APPLICATION TO THE ZONING BOARD OF ADJUSTMENT

Denial Memorandum

Applicant: Mogul Group, LLC
Address: 34 Forrest Avenue, Rumson, New Jersey 07760
Block 42, Lot 1, Zone: R-5

Zoning Board Revisions

PLOT/GRADING PLAN

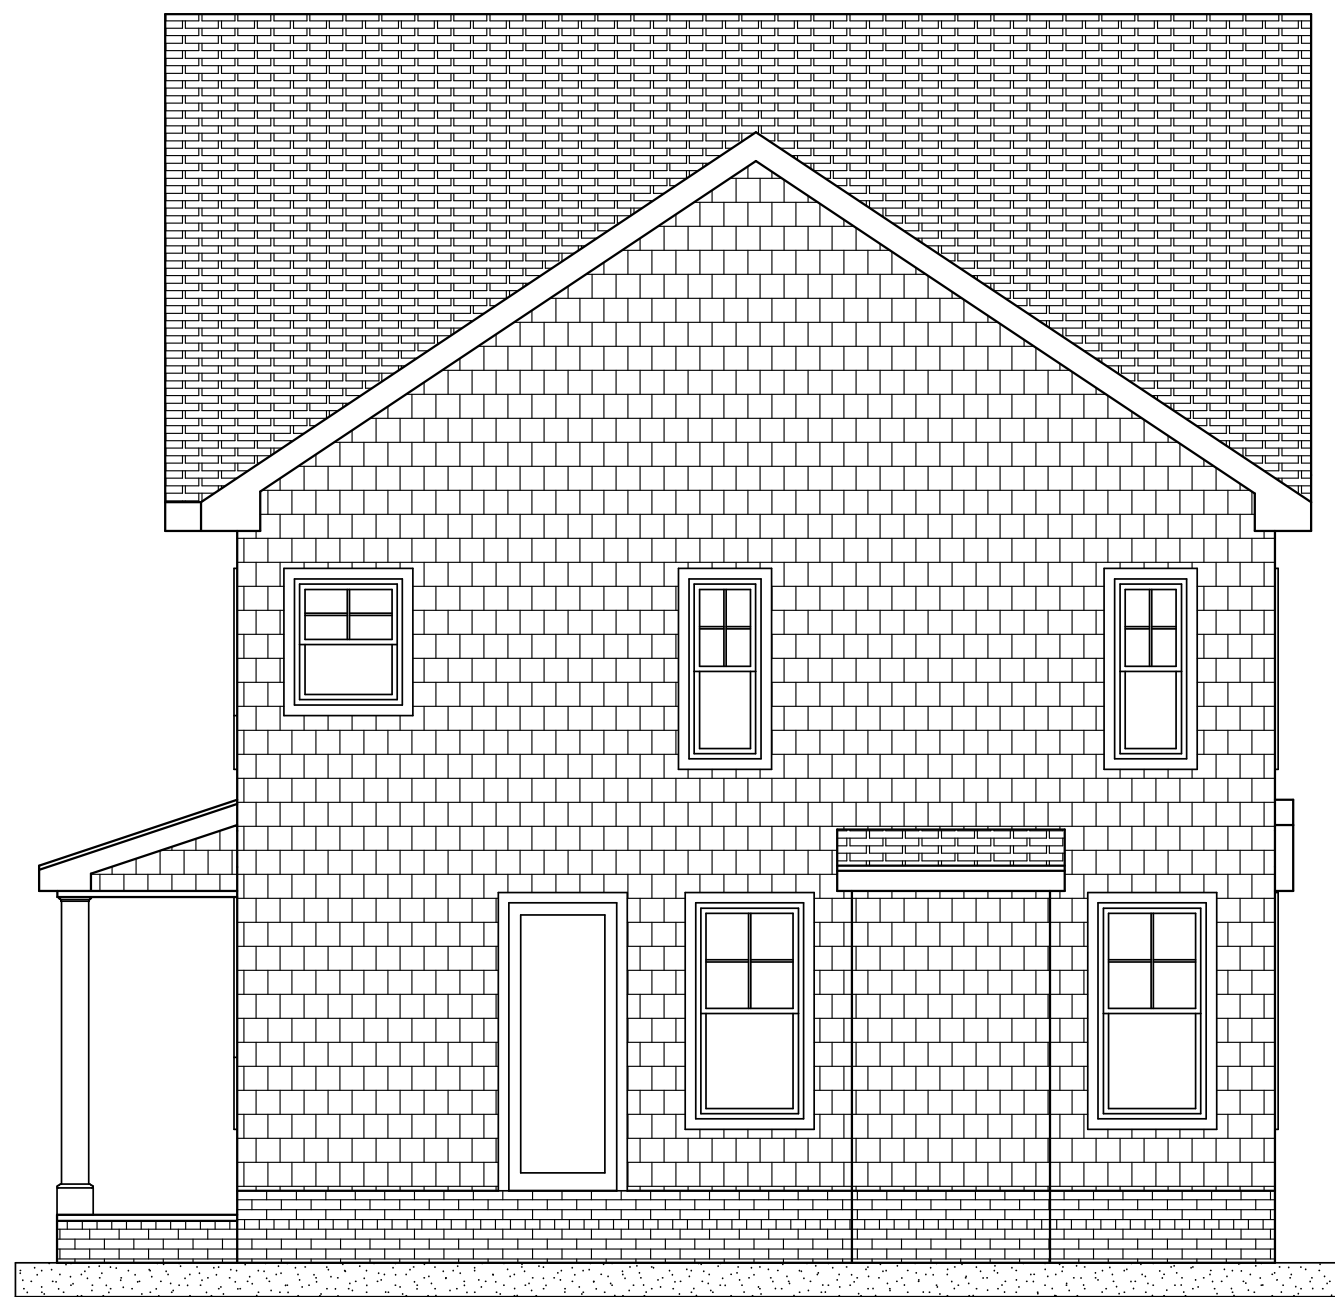
- Schedule 5-1 bulk variances
 - (Principal Bldg.) Secondary front yard setback of 12', whereas 35' is required (**New**).
 - (Principal Bldg. Porch) Secondary front yard setback of 7', whereas 35' is required (**New**).
 - (Accessory Bldg.: detached garage) Secondary front yard setback of 23.5', whereas 35' is required (**New**).
 - Minimum Lot Area of 7,836-sf, whereas 8,000-sf is required (**Existing, unchanged**)
 - Minimum Lot Frontage/Width of 50', whereas 75' is required (**Existing, unchanged**)
 - Minimum Corner Lot Shape Requirement of 7', whereas 33' is required (**Existing, unchanged**)
- (22-9.2b) Parking in the front yard setback (**New**).

1	11-07-25	PER ZONING OFFICER'S REVIEW OF 20 OCTOBER 2025
---	----------	--
